UNITED STATES PATENT AND TRADEMARK OFFICE

APPLICATION NO.	FILING DATE	FIRST NAMED INVENTOR	ATTORNEY DOCKET NO.	CONFIRMATION NO.
10/701,026	11/04/2003	Michael Schmid	P2002,0949	6160

Office Action Summary

DETAILED ACTION

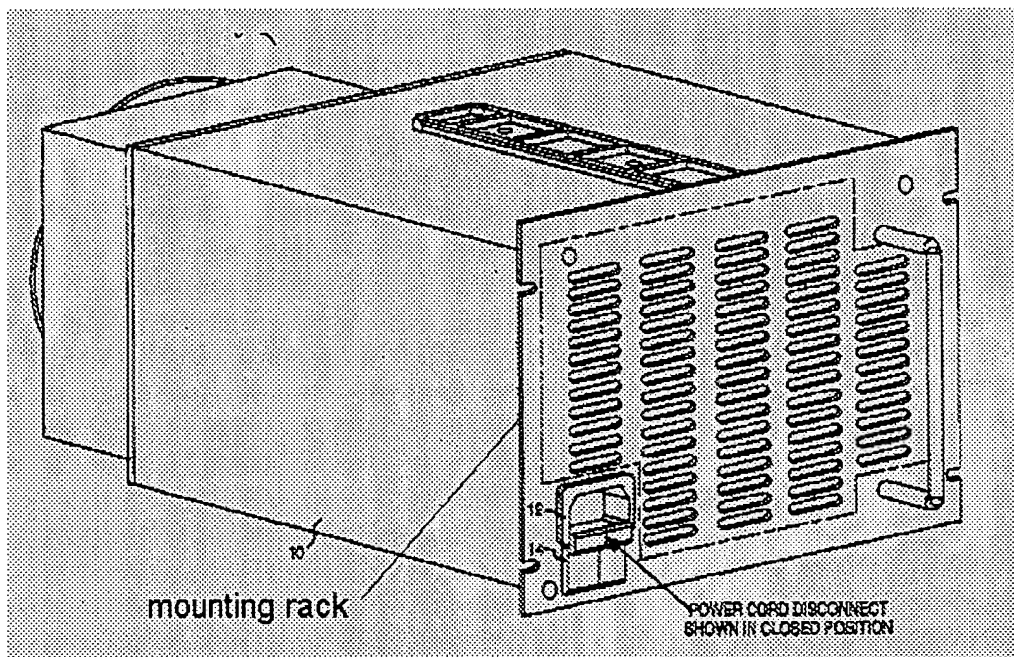
Regarding claim 2, Jarrett discloses the power supply further comprising a mounting rack (see following figure), and the insertion protection device is a slide (please note that element 14 slides between the positions shown in Fig.2 and 4) disposed in the mounting rack.
